Permit # _____ City of Portland BUILDING PERMIT APPLICATION Fee 15. Zone _____ Map # _____ Lot# _____

BUILDING PERMIT REPORT

ADDRESS: 121 Deepwood Drive DATE: 12/20/91

REASON FOR PERMIT: construct one family dwelling with 2-car garage as per plans

From Plan of Land
for Richard Minucci
by Titcomb Assoc.
11/14/91

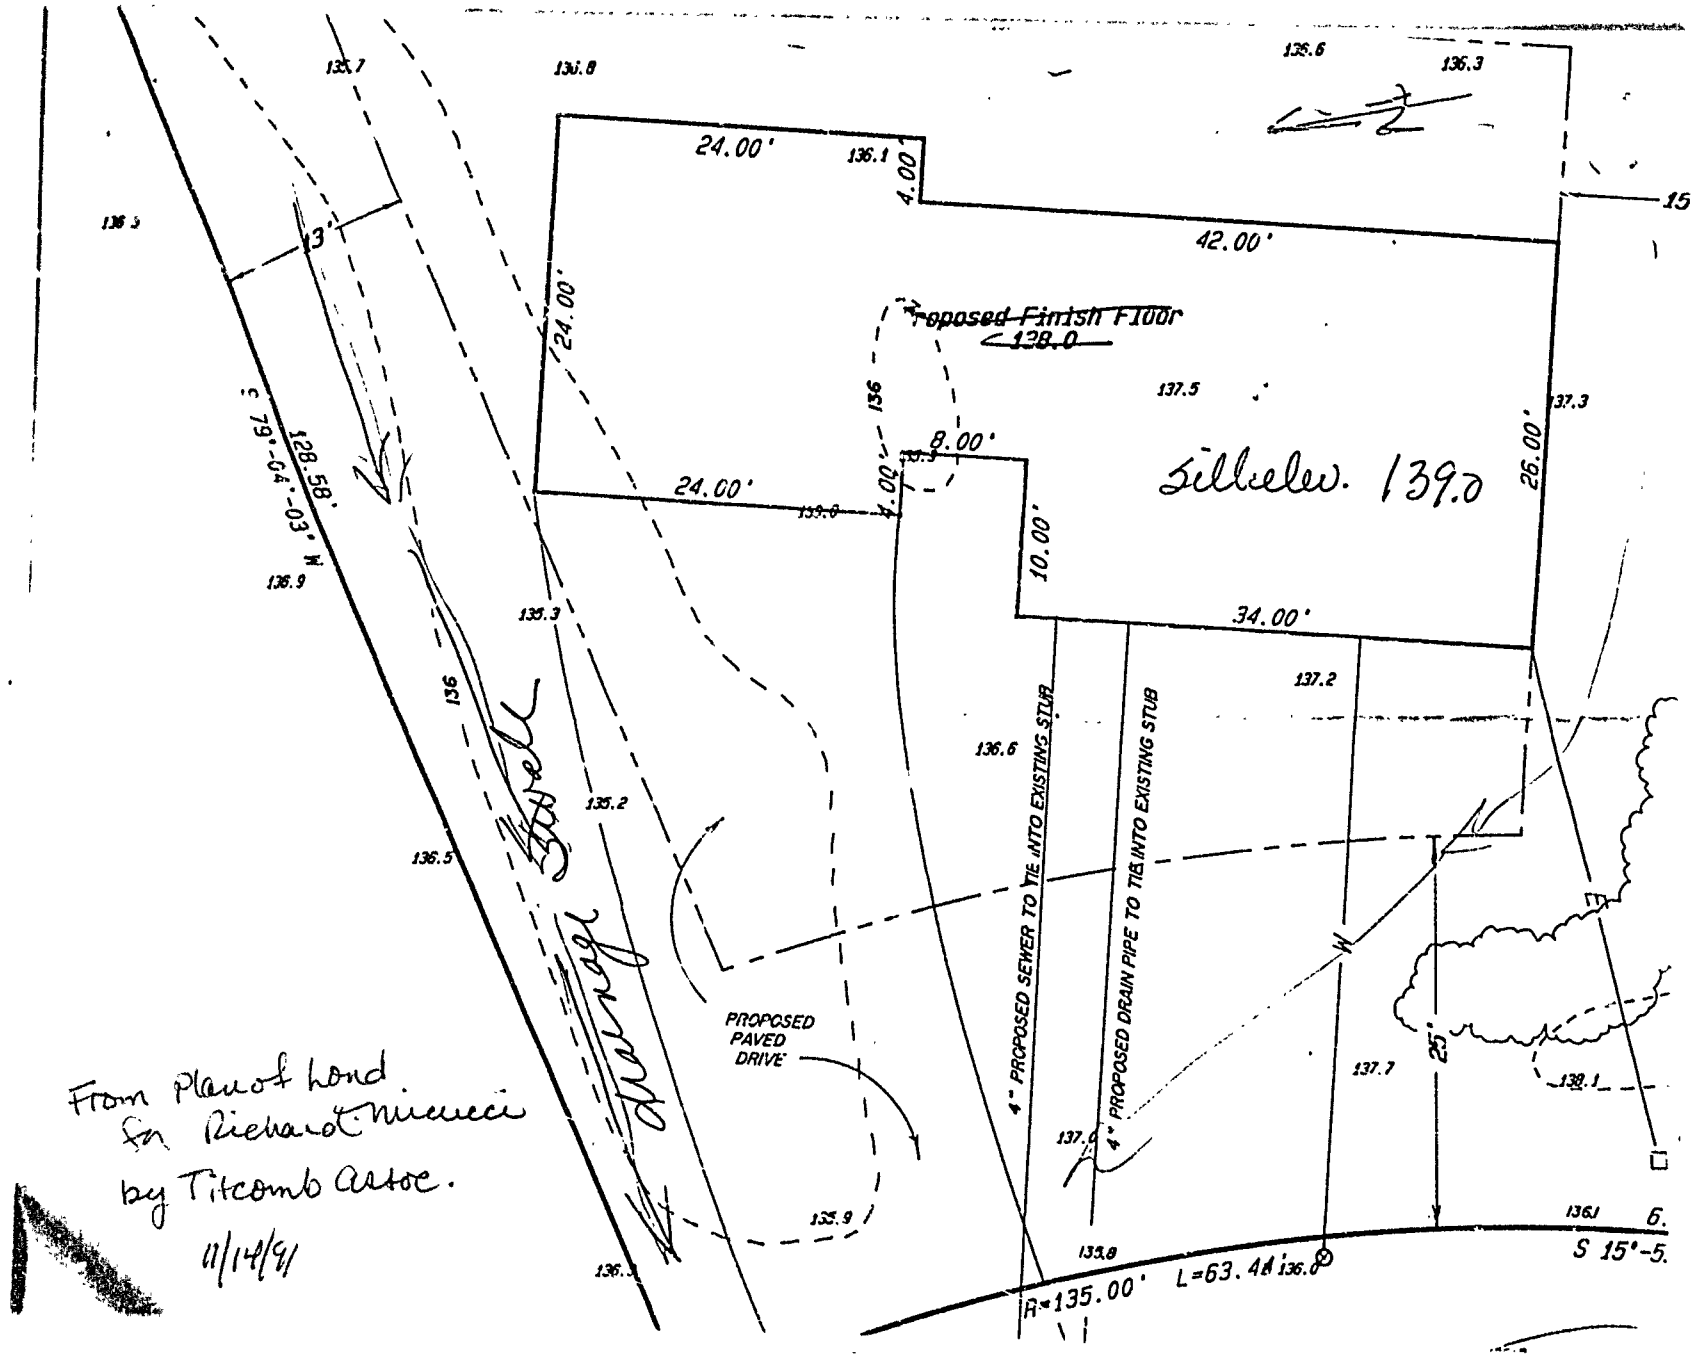
REASONS: Sill elevation to be 139.0' - See
copy of ~~add~~ site plan
- Contractor will construct drainage
Swale @ northerly property line. (adj to lot 22)
(Attach Separate Sheet if Necessary)

1. See attached site plan review conditions of approval
2. The sill elevation to be 139.0' - See copy of site plan.
3. Contractor will construct drainage swale at northerly property line (Adjacent to Lot 22).
